Addendum No. 2
December 10, 2021

Project: Harrisburg High School - 9th Grade Academy
Sioux Falls, South Dakota
Architecture Incorporated Project #2904

Architect: Architecture Incorporated

GUARDRAIL DETAIL – 10/5.42 – STORAGE A201
REF SECTION 2/5.40

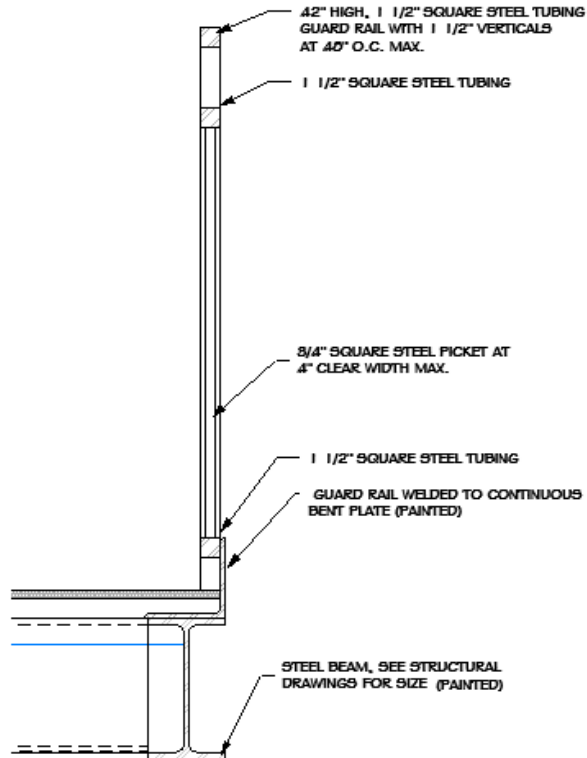
- i) Reference the guardrail detail below which is to be utilized at Storage A201.

DETAIL 26/4.32

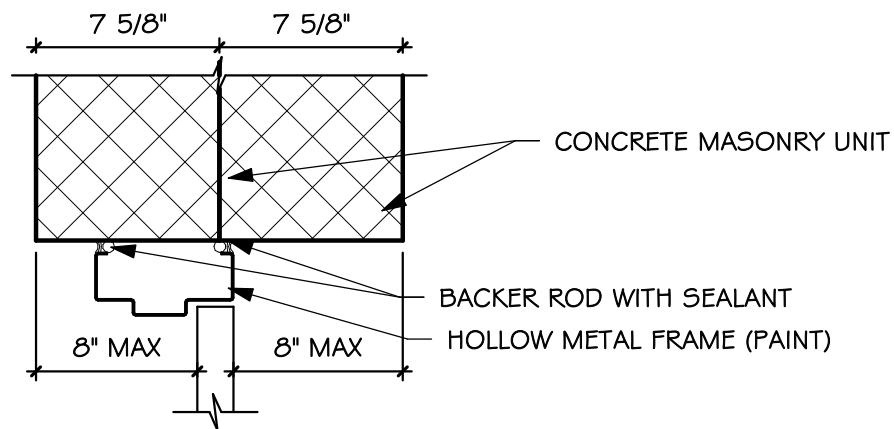
- b) Door D103: The Contractor shall provide a light gauge metal plate at the head of door D103 to close the gap that will be created between the two (2) steel lintels; plate to be welded in place. Exact details to be coordinated with Contractor at later date.
- c) Door D103: Provide door hardware Group #9 in lieu of Group #1.
- d) **CORRECTION:** Per Addendum No. 1 the head detail at doors D014A and D118 was incorrectly identified as 7/4.32. The correct head detail should actually be *revised* detail 26/4.32 (i.e. – 1/SD-7) as indicated on supplemental drawing SD-7 (attached to the end of Addendum No. 2).
- e) **CORRECTION:** Per Addendum No. 1 the jamb detail at door D014A and D118 was incorrectly identified as 7/4.32. The correct jamb detail should actually be *revised* detail 26/4.32 (i.e. – 2/SD-7) as indicated on supplemental drawing SD-7 (attached to the end of Addendum No. 2).

- iii) Borrowed lite Type '8A': Change head detail to 15/4.31, change jamb detail to 16/4.31 and change sill detail to 17/4.31.
- c) Detail 26/4.32 and 27/4.32: Change door frame head to 4" head. Locate door frame 7 5/8" from the face of the CMU to cover the joint between the concrete blocks and locate the north face of the door 7 5/8" from the face of the wall.

5.57

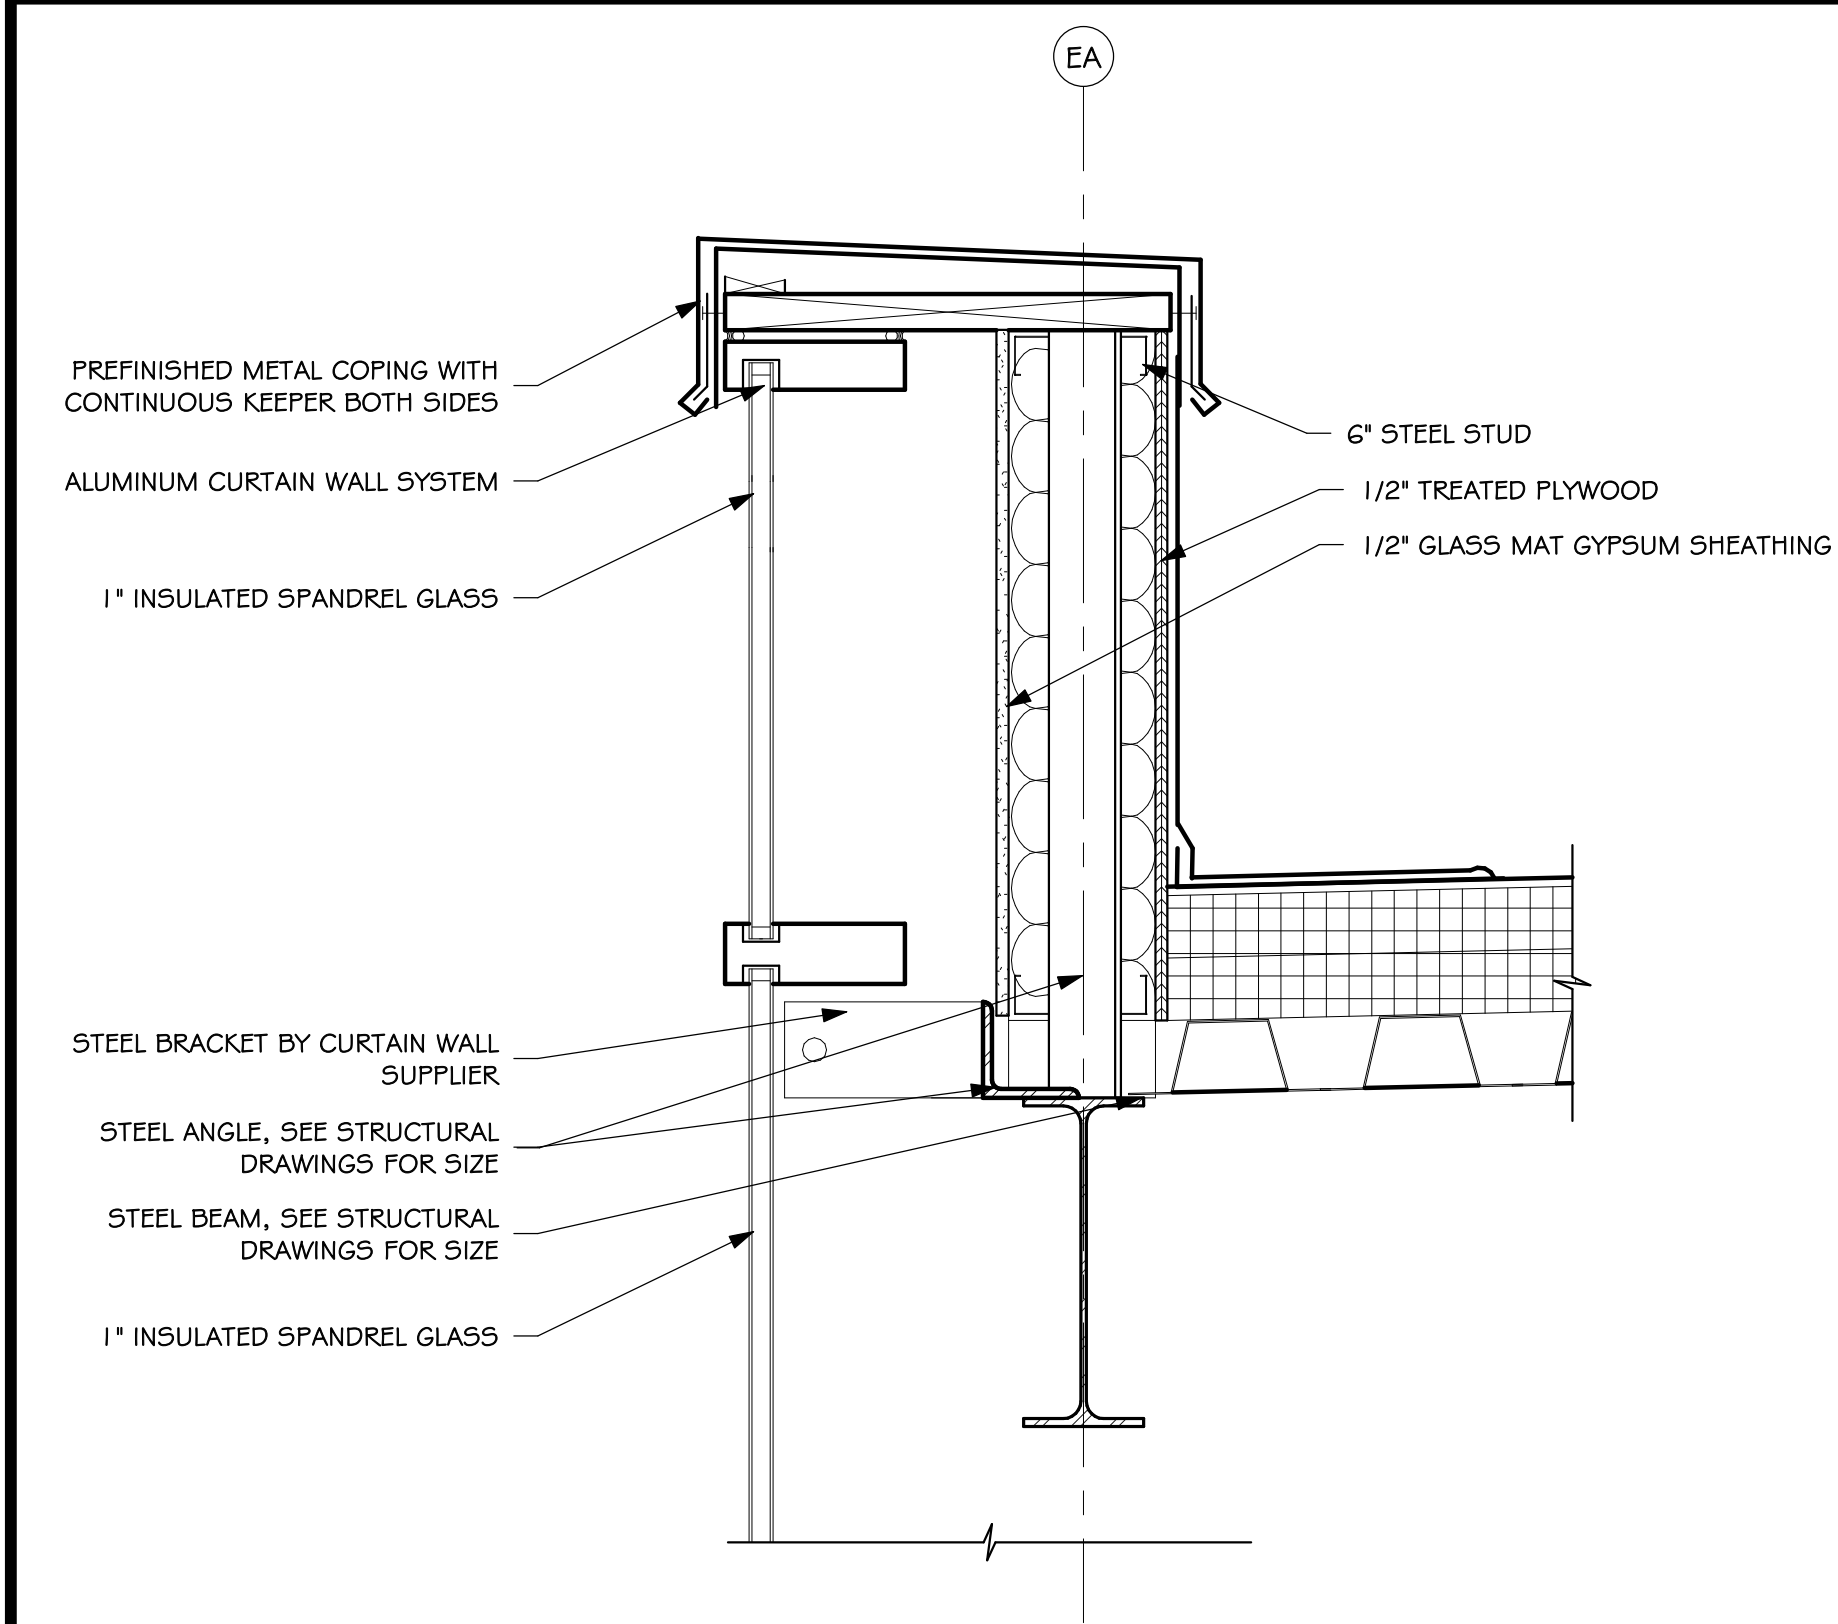
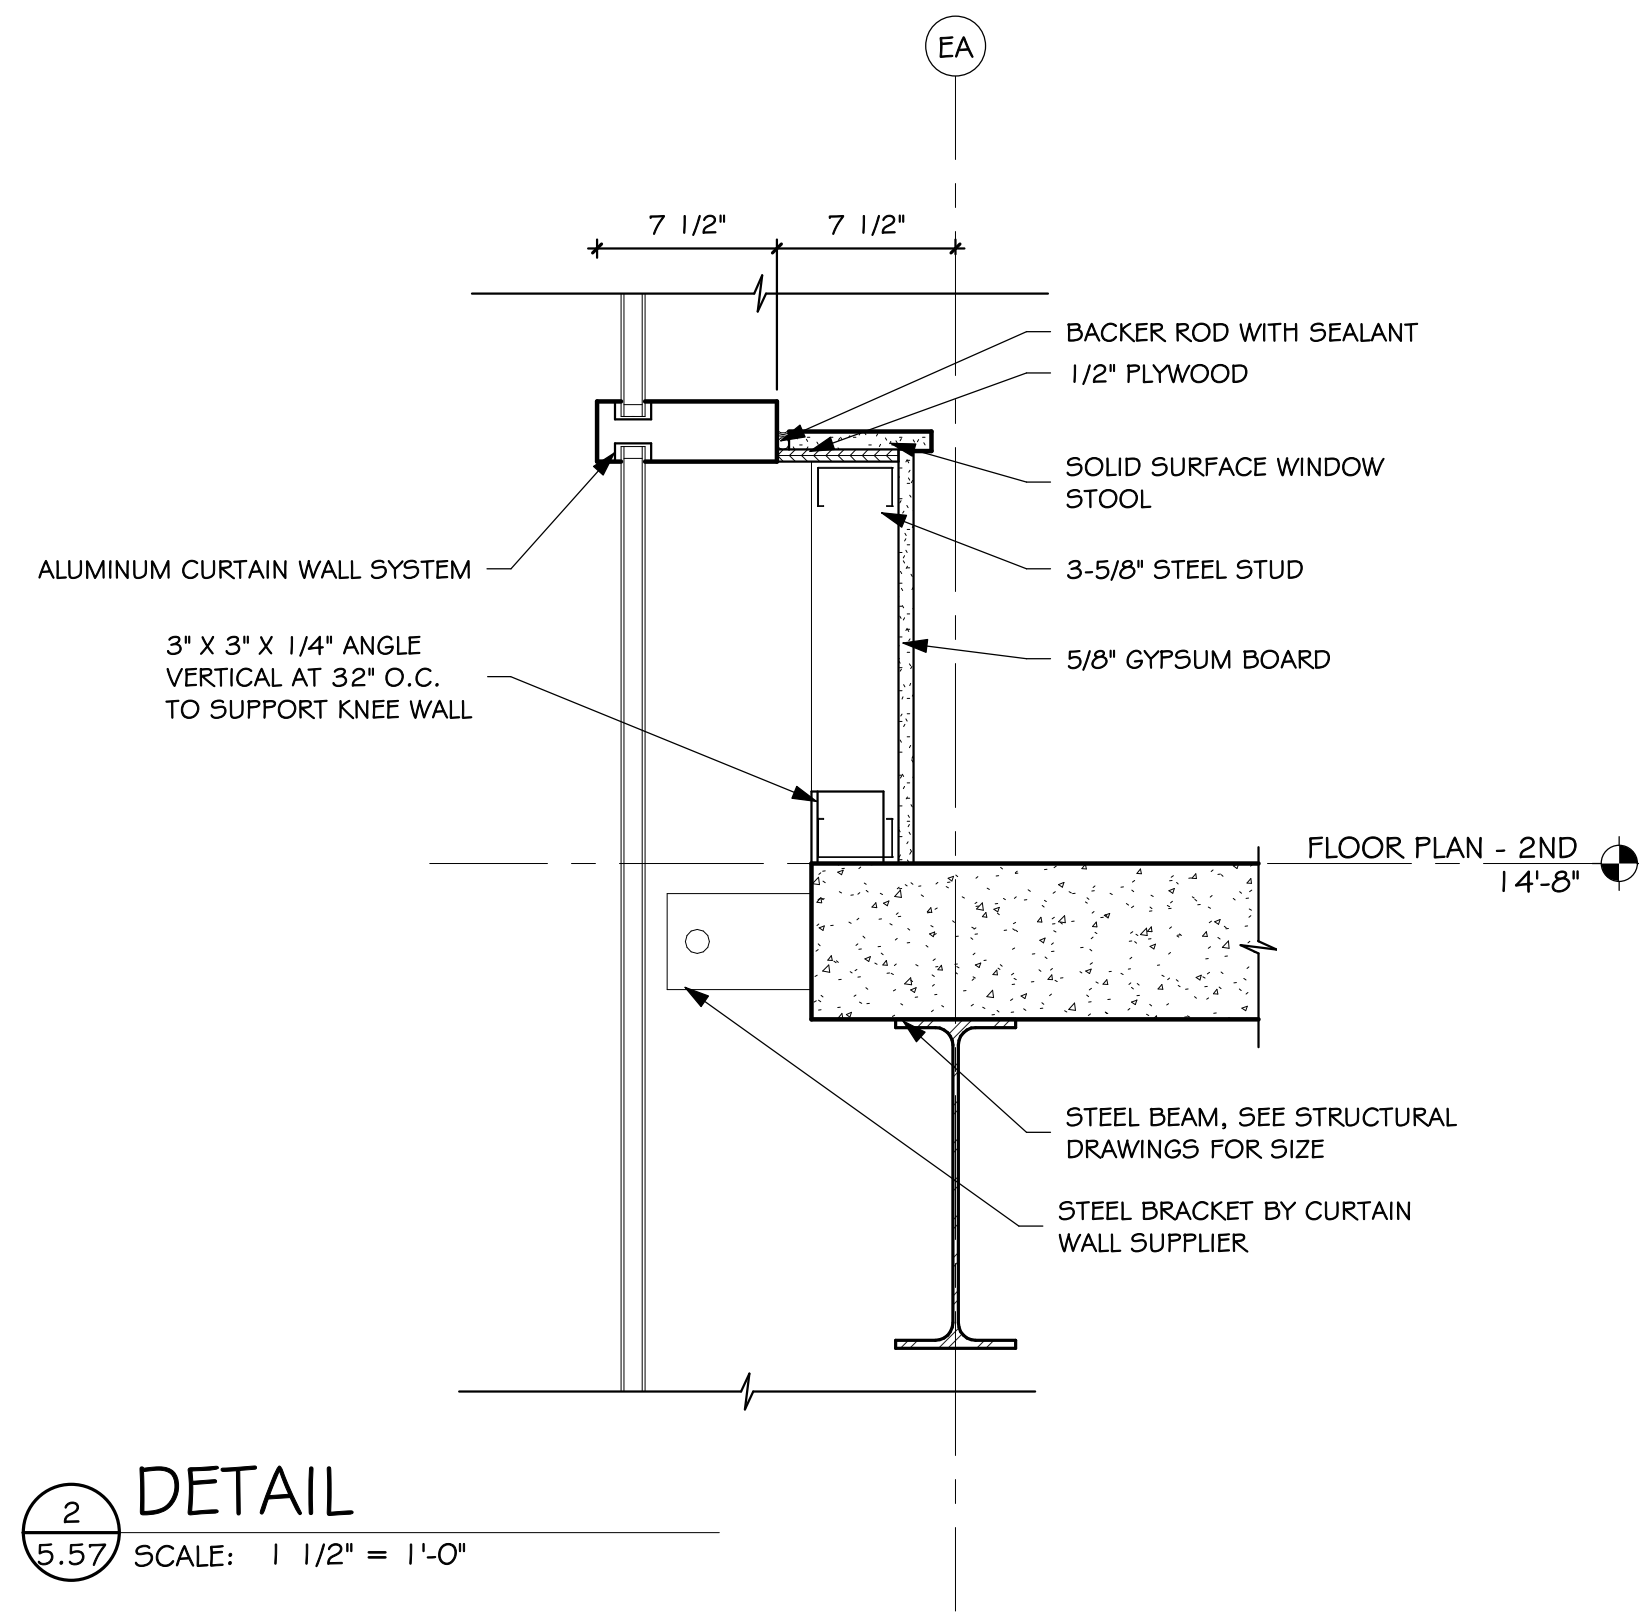
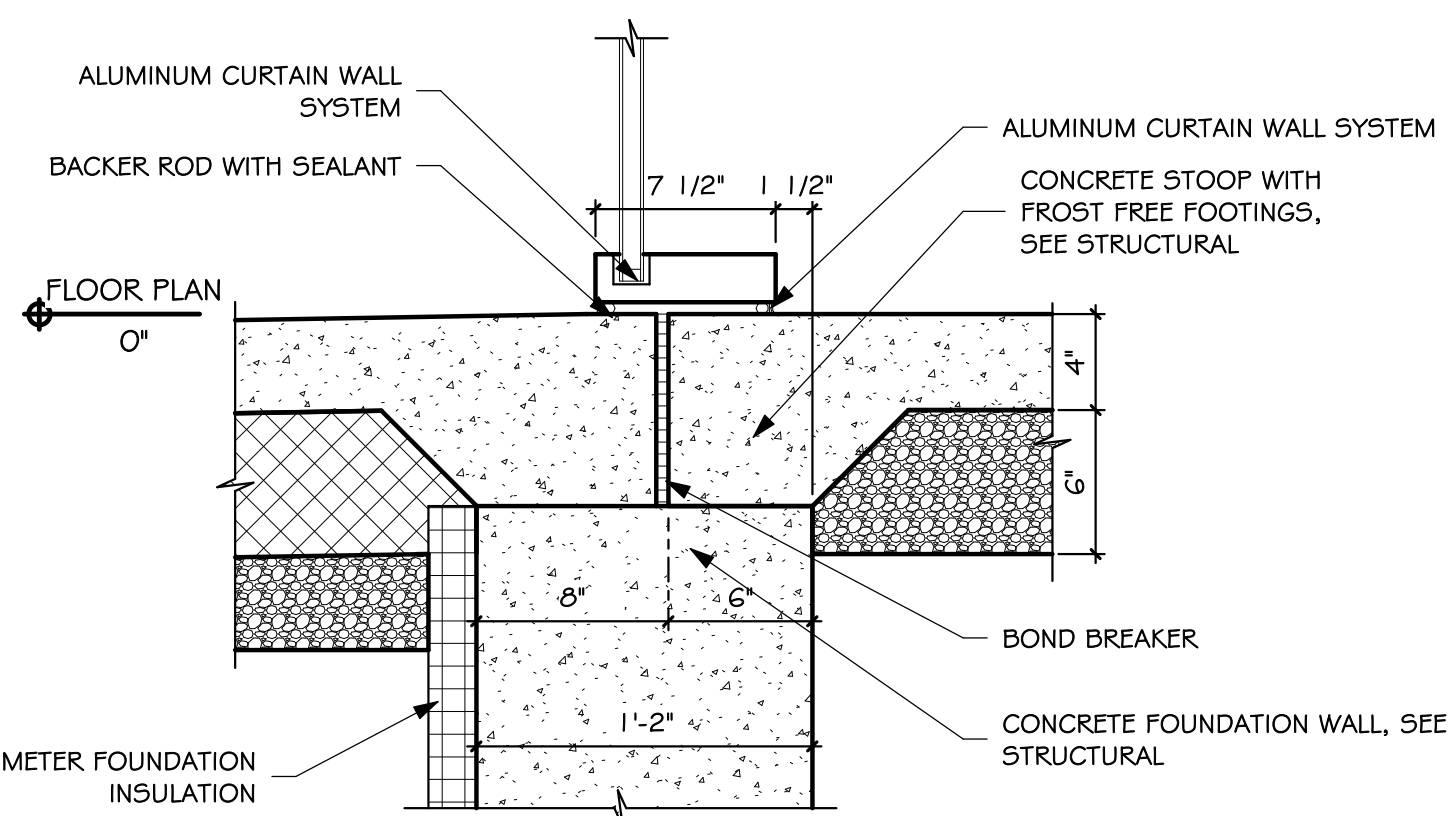
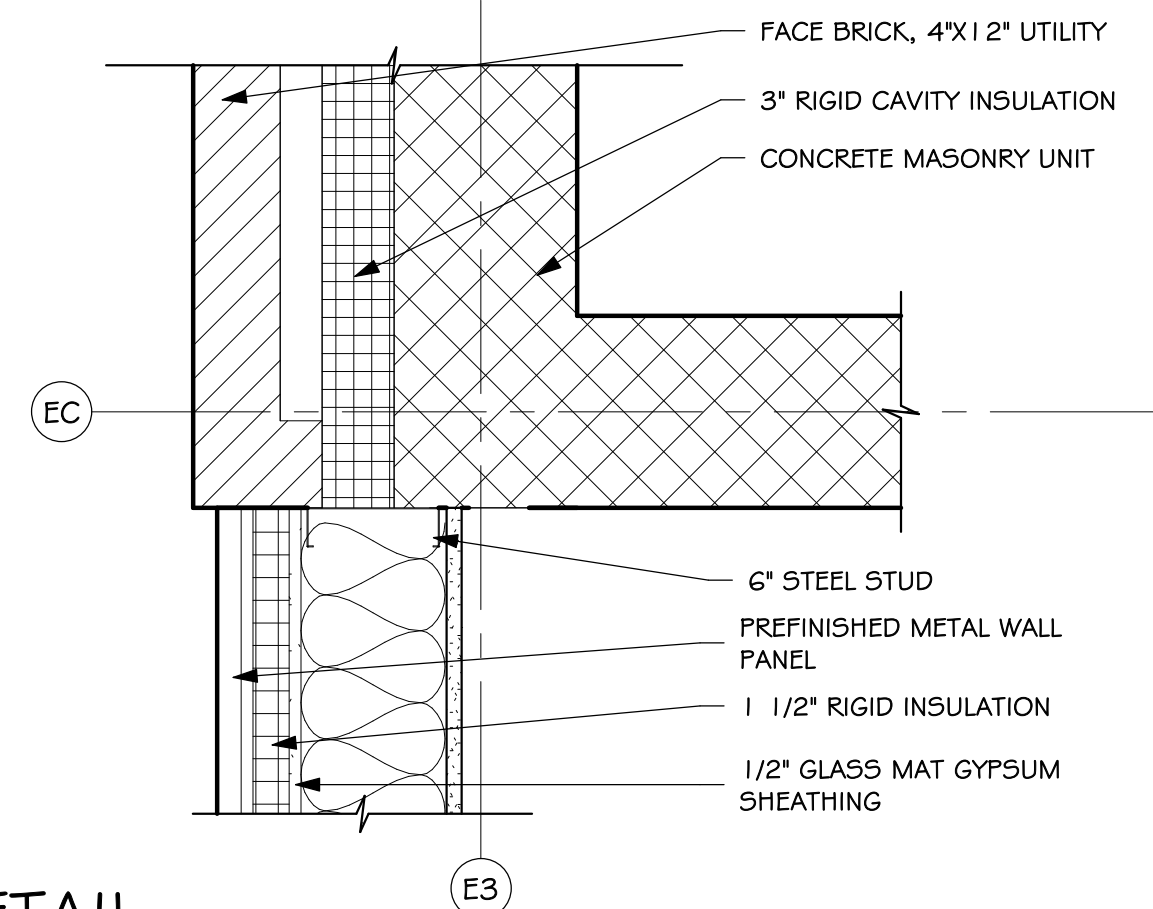
- a) See attached **NEW** architectural drawing Sheet 5.57 with new enlarged details per below:
 - i) Details 1, 2 & 3/5.57 – refer to building section J/5.34, grid EA for location of these details.
 - ii) Details 4, 5/5.57 – refer to building section B/5.36 for location.
 - iii) Reference new exterior building elevation 7 / 5.57 which now shows the west exterior elevation of Area E – per the Base Bid.
